October 12, 2016

MODENA STREET (HARRISON TO SPRING) SIDEWALK

Addendum #1

SHEET X-5

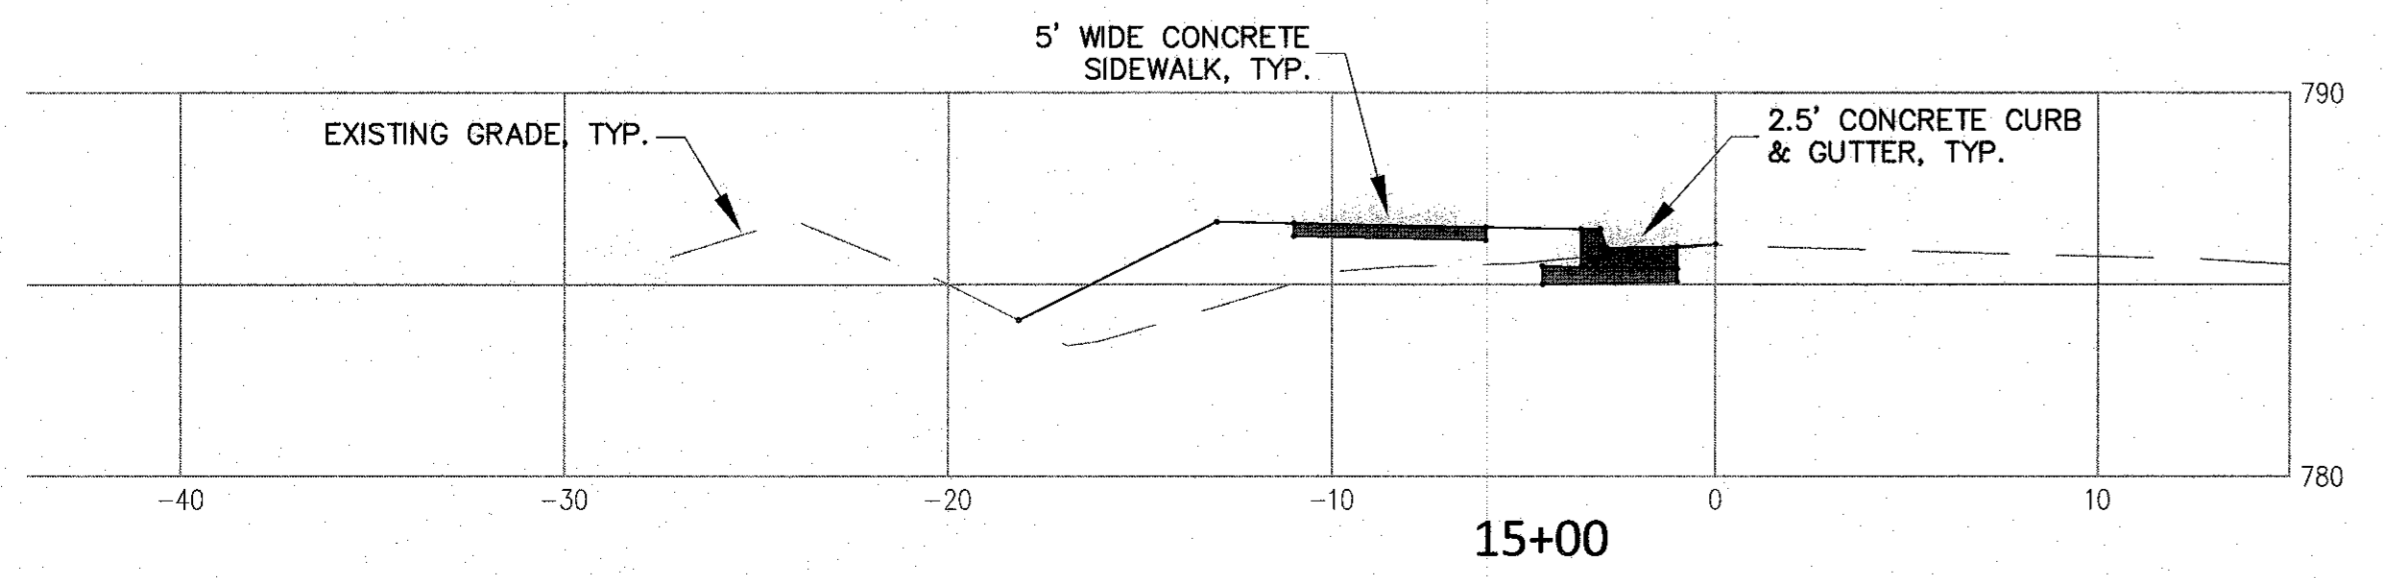
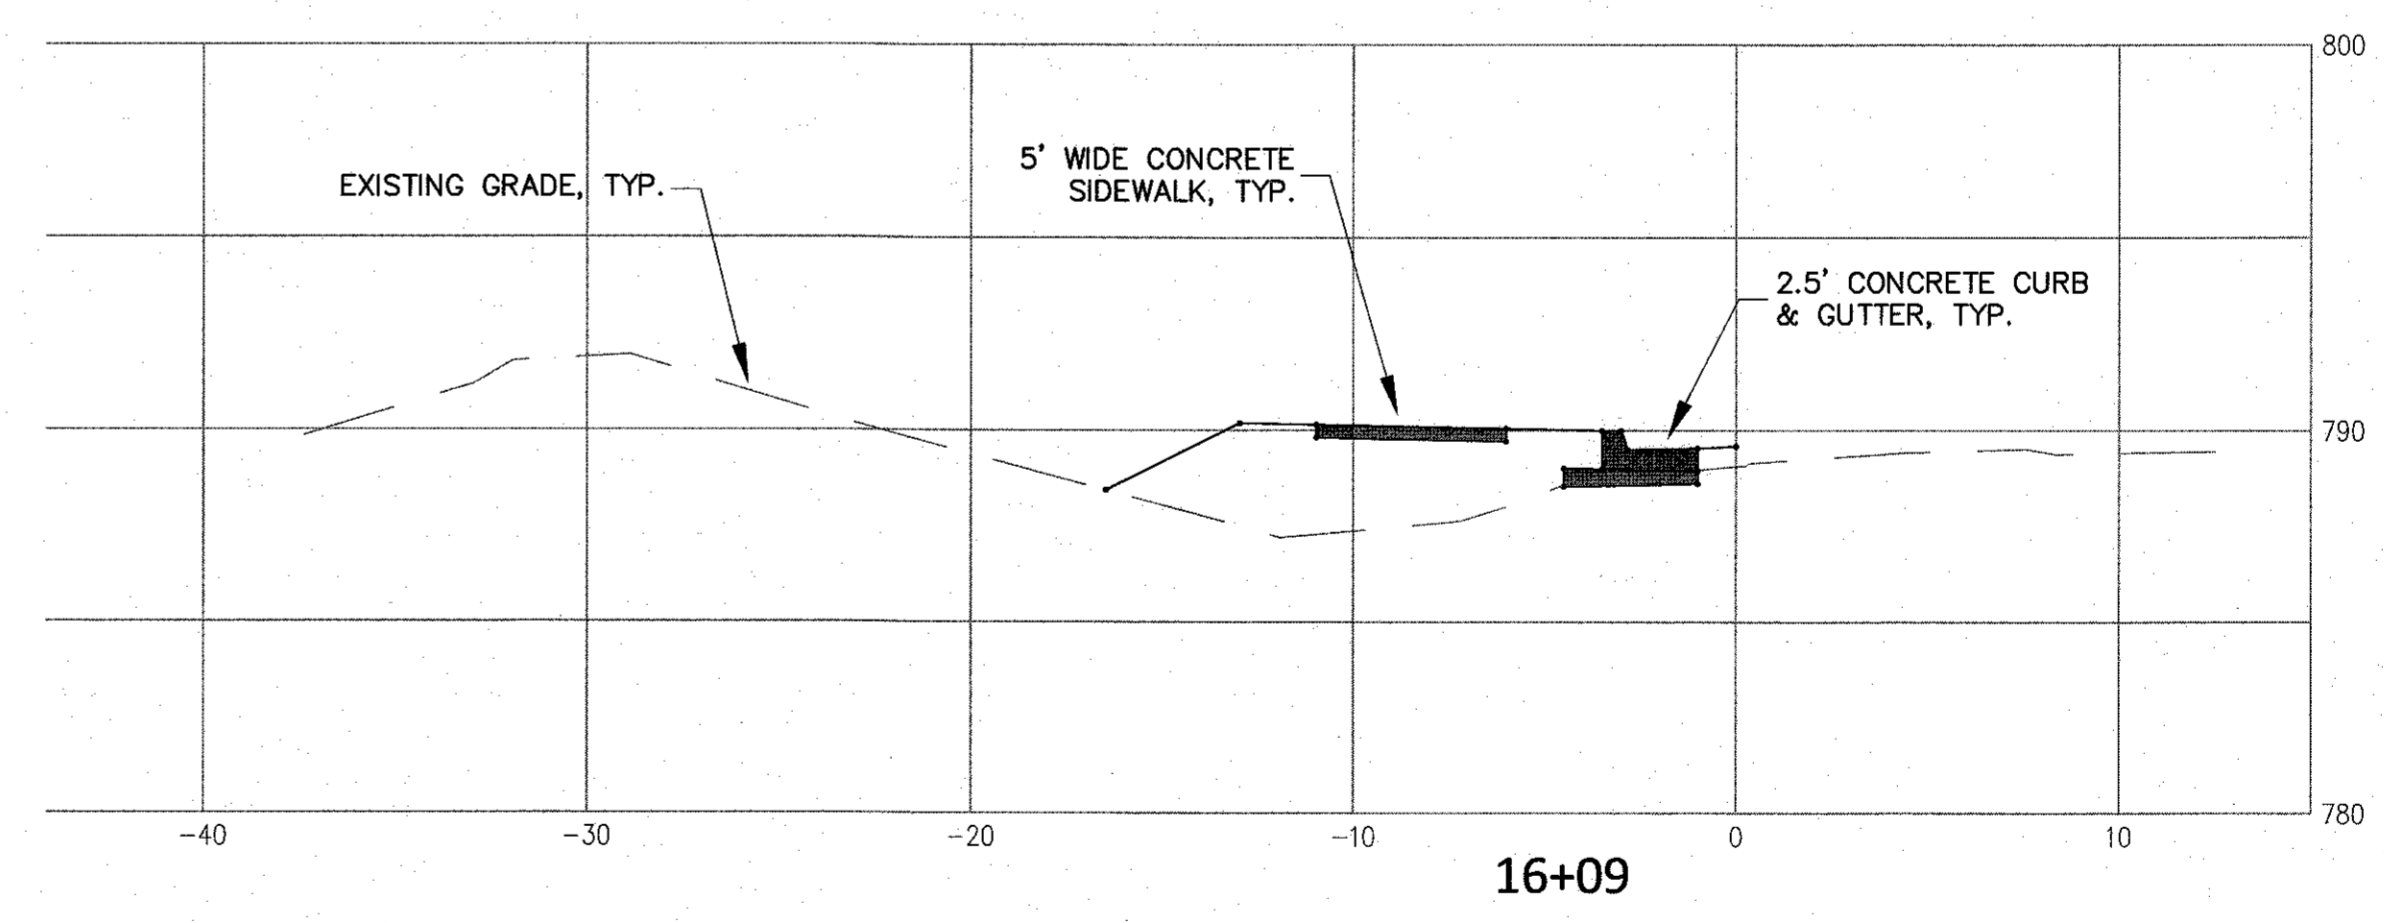
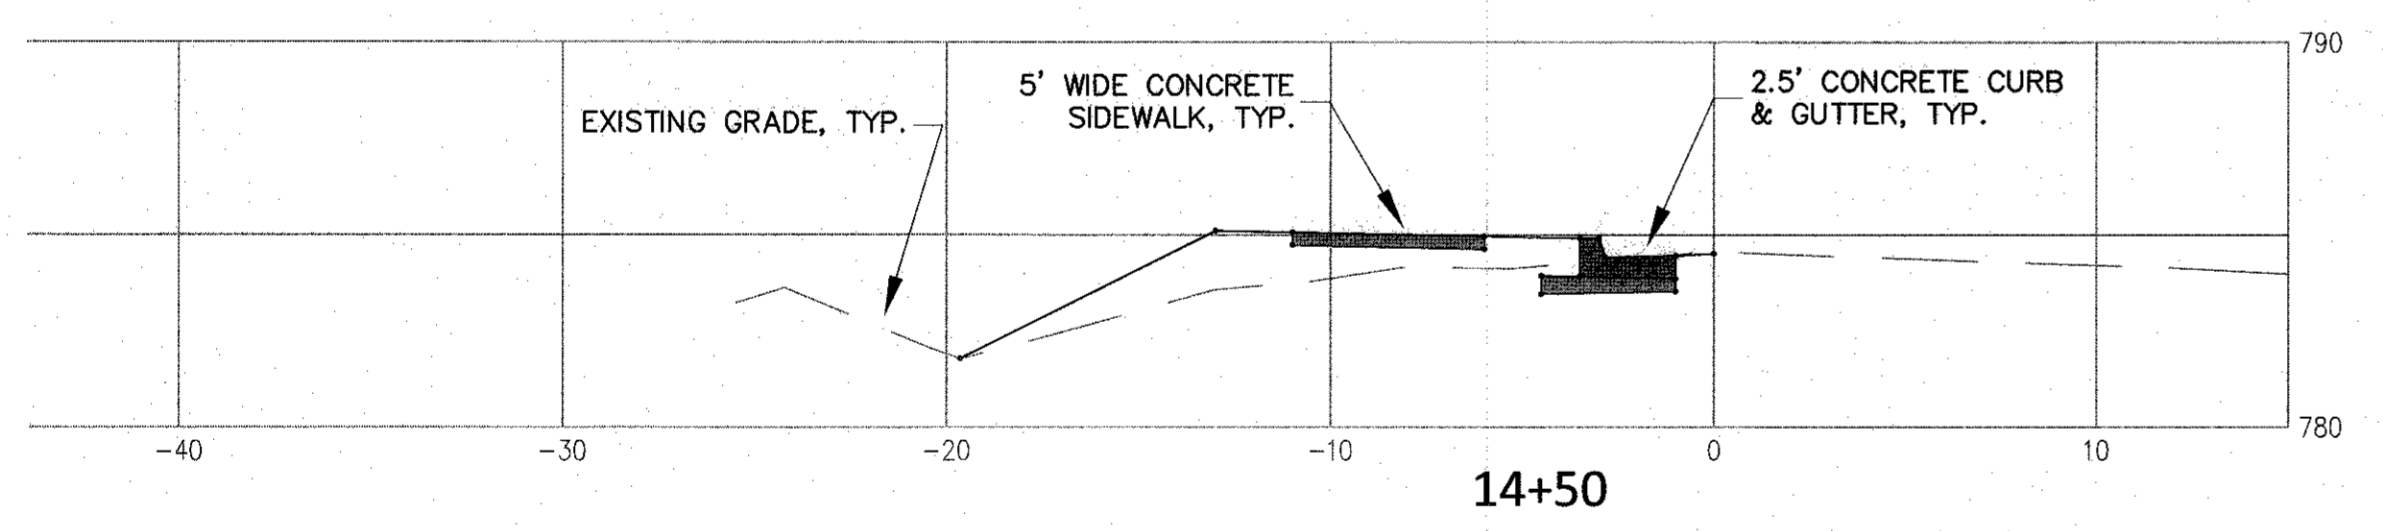
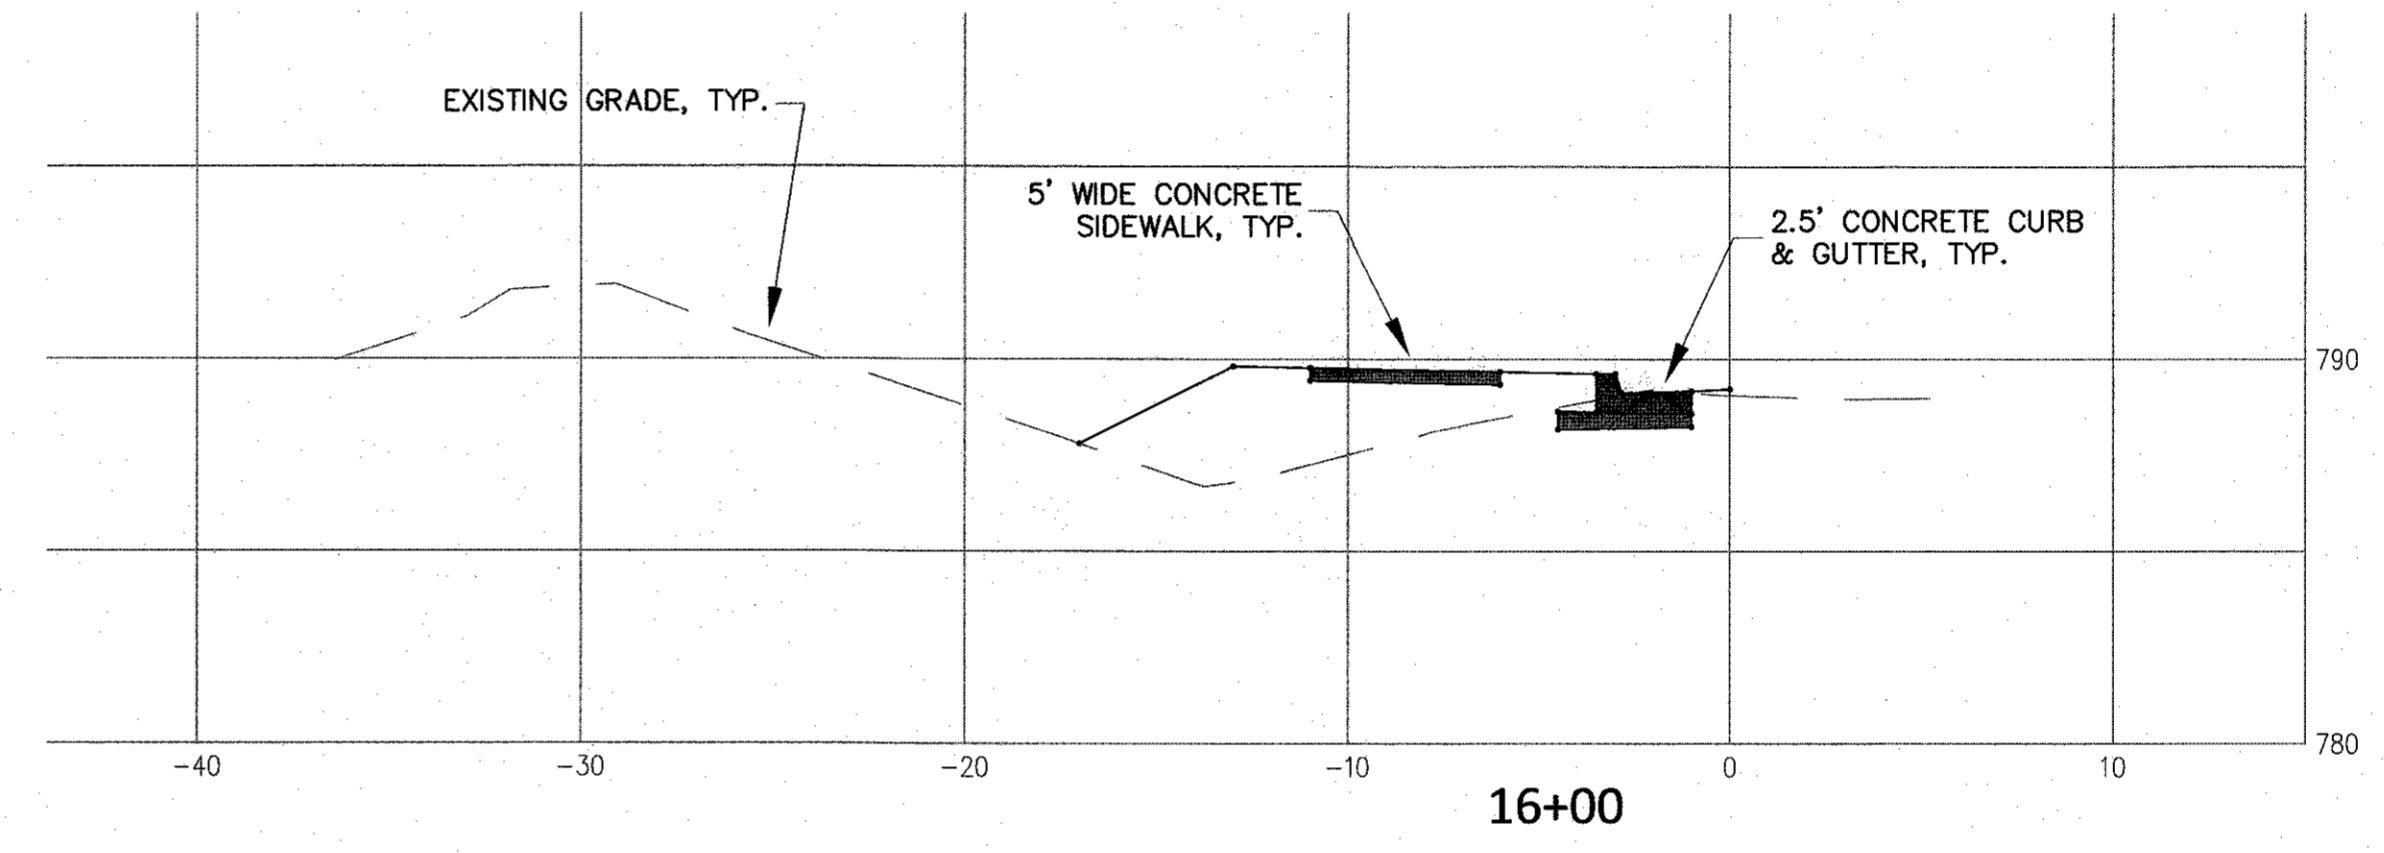
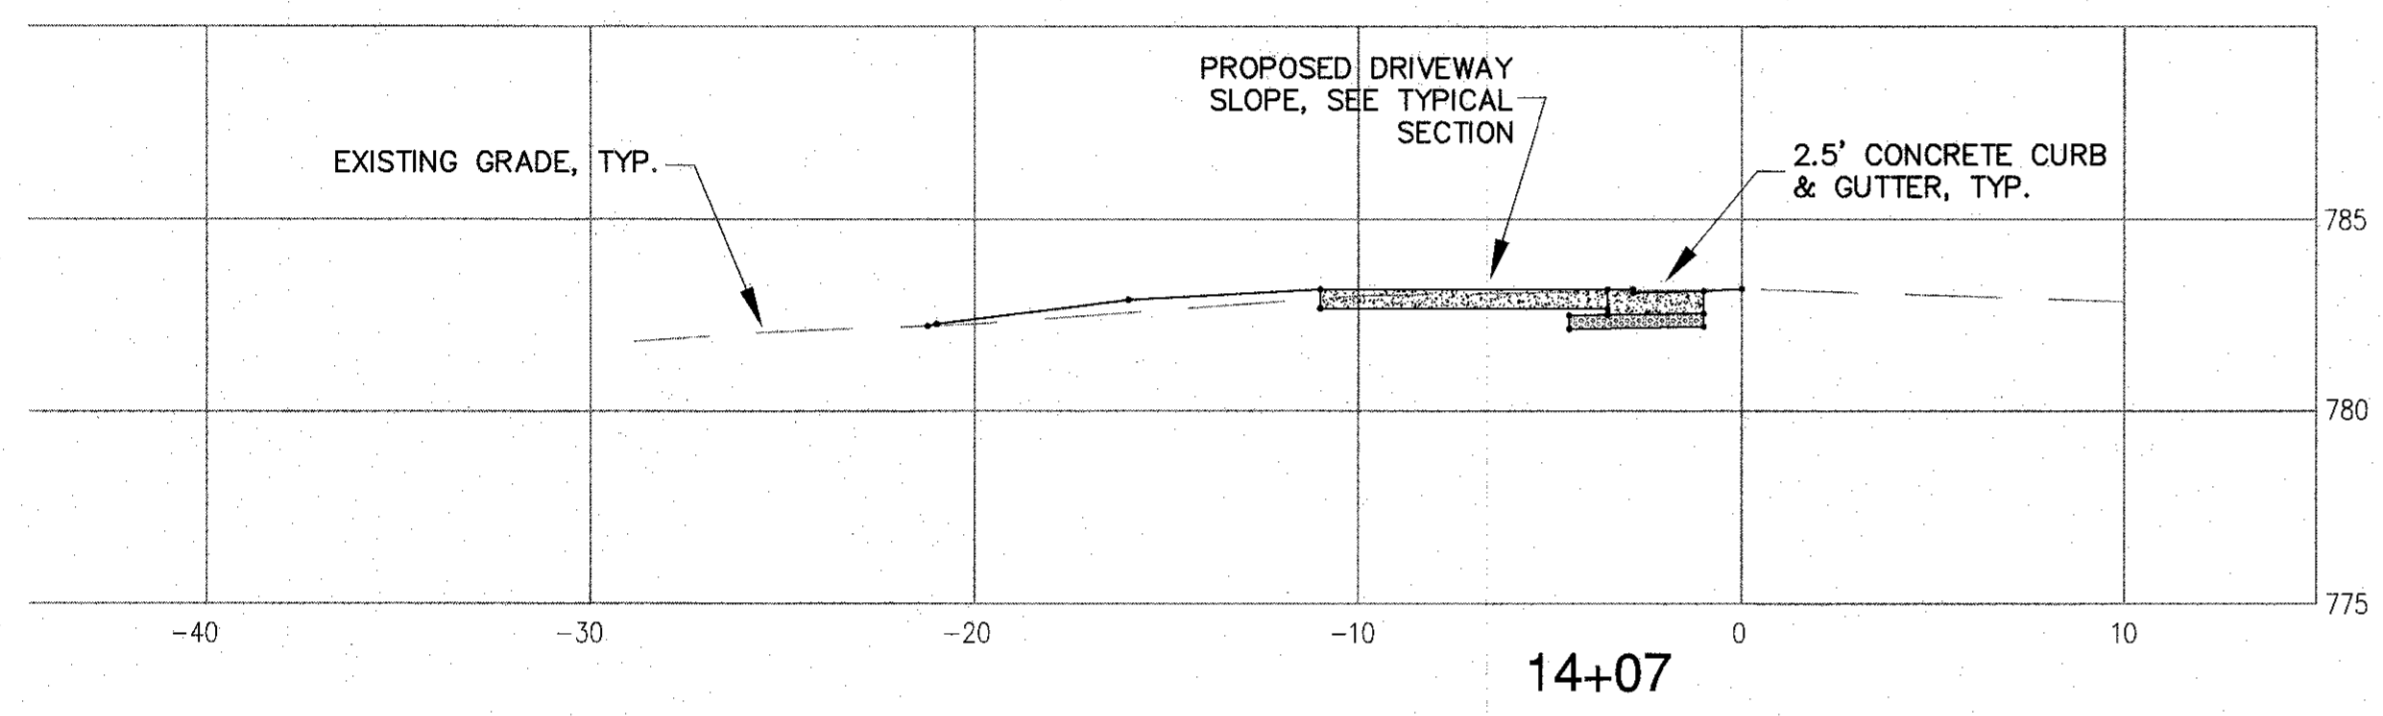
- Additional cross sections for proposed sidewalk from Sta. 0+00 to 9+00 and 13+50 to 16+09. (X-1 thru X-5) are attached to this Addendum. If you have already picked up your bid documents and plans, and would prefer a hard copy of the revised sheets, please contact caryr@cityofgastonia.com.
